REFERRAL REPORT

TO: Vancouver City Council

FROM: General Manager of Planning, Urban Design and Sustainability

SUBJECT: Vancouver ODP Amendment: (i) 500 Dunsmuir Street, 619-655 Richards Street, 501-565 West Georgia Street and (ii) 388 Abbott Street and CD-1 Rezoning: (i) 500 Dunsmuir Street, 619-655 Richards Street, 501-595 West Georgia Street and 620-698 Seymour Street and (ii) 388 Abbott Street

Figure 1 - Tower height comparative analysis

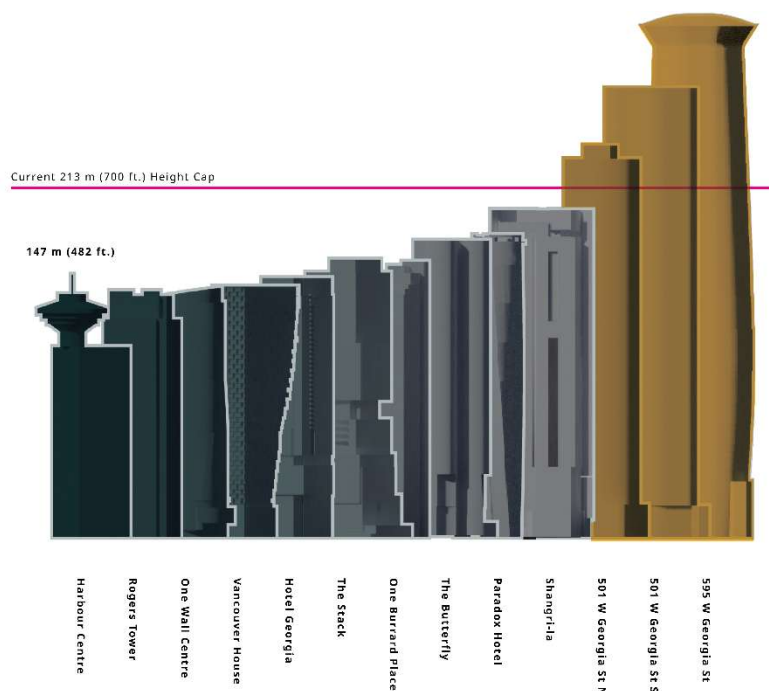
The proposed tower heights substantially exceed those anticipated by existing policy and would introduce a new vertical scale to the downtown peninsula. The West Tower, at over 300 m (1,000 ft.), would become one of the tallest buildings in Canada and a highly prominent element in the regional skyline. Figure 1 compares the heights of the three proposed towers, shown in yellow, with existing landmark towers in downtown Vancouver.

Buildings of this magnitude are visible from a wide range of public vantage points and function as city-wide landmarks rather than solely site-specific structures. As a result, their architectural quality, proportions, crown treatment, and compositional relationship to one another become matters of broad civic importance.

Figure 2 - Proposed Richards Street frontage compared with typical nearby Downtown podium conditions

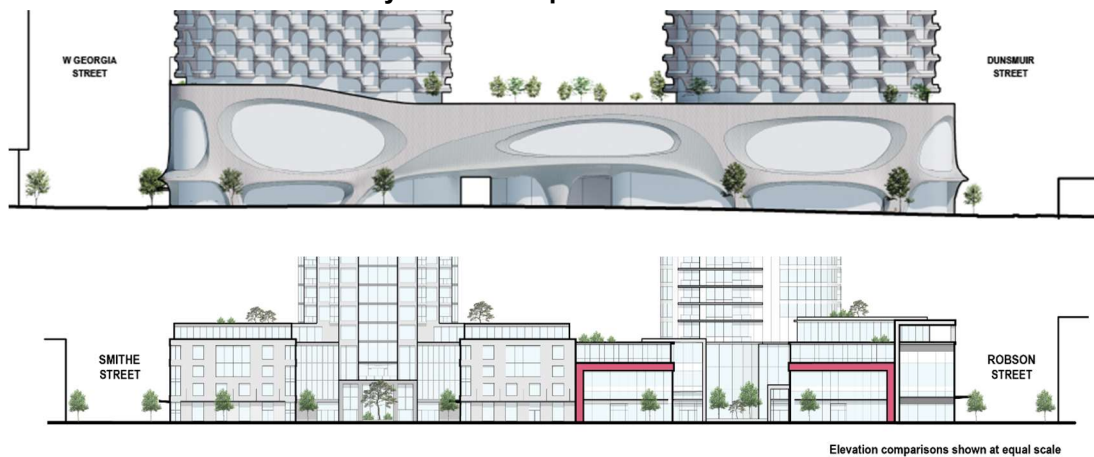
Along Richards Street in particular, the proposal presents an extended podium frontage of approximately 152 m (500 ft.) with limited substantive volumetric shifts in plane or massing expression. Figure 2 compares this interface with the more typical finer-grained, pedestrian-scaled mixed-use podium condition found in the nearby 800-block of Homer Street, which, while more conventional and less formally expressive in its architectural language, similarly accommodates a mix of residential lobby entries and commercial retail units while providing clear variation in vertical and horizontal plane that contributes positively to pedestrian scale.

While the broader architectural concept emphasizes smooth, continuous sculptural forms, that approach does not readily lend itself to the finer-grained base conditions typically associated with successful pedestrian-scaled streets. As proposed, the Richards Street frontage may read as visually elongated and out of context with the established rhythm of surrounding development, potentially diminishing the comfort, interest, and human scale of the street environment. The Urban Design conditions of approval in Appendix C1, anticipate further design development to explore stronger modulation, frontage differentiation, and vertical or horizontal articulation to better respond to the surrounding urban fabric.

Along Seymour Street, where the West Tower meets the sidewalk more directly, careful treatment of the base is especially important. Additional landscape expression, robust planting, water features, and the mitigation of recessed inactive alcoves would assist in softening the scale of the tower base and improving the pedestrian experience.

Figure 3 - Queen Elizabeth Park public view impact diagram

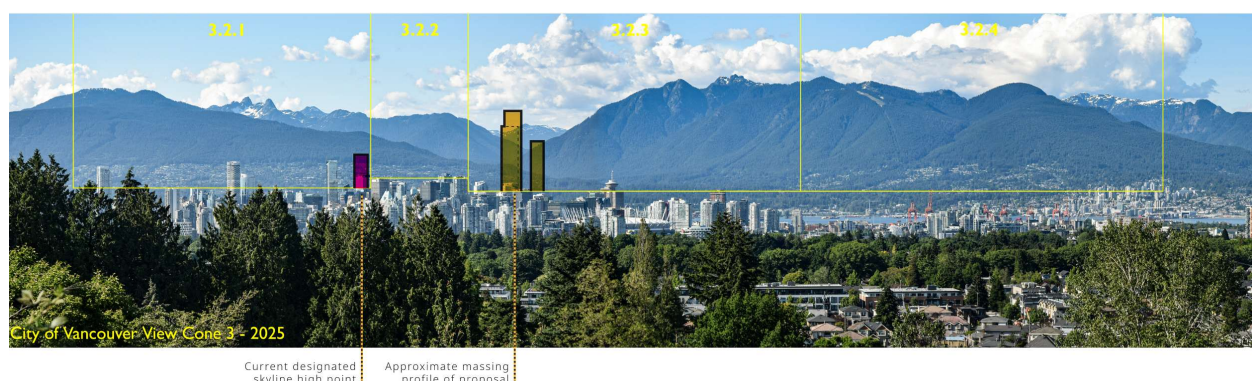
The site qualifies for consideration as an Exceptional Downtown Site under the *Public Views Guidelines* (2024, last amended 2026), and the proposal includes encroachments into view cone boundaries of the Queen Elizabeth Park public view. While policy contemplates some flexibility for exceptional sites, the extent of the proposed encroachments exceeds that associated with previously approved higher buildings. Figure 3 approximates the impact of the massing profile of the proposal, shown in yellow, within the Queen Elizabeth Park public view. For comparison, the massing profile of the tallest building currently contemplated by the *Higher Buildings Policy* is shown in pink.

While the *Higher Buildings Policy* permits consideration of tower forms encroaching into the Queen Elizabeth Park view cone, the heights enabled through that framework are generally calibrated such that buildings do not pierce the ridgeline of the North Shore Mountains when viewed from Queen Elizabeth Park. By contrast, the proposed towers extend materially above the ridgeline in portions of the protected view, interrupting the visual continuity of the mountain
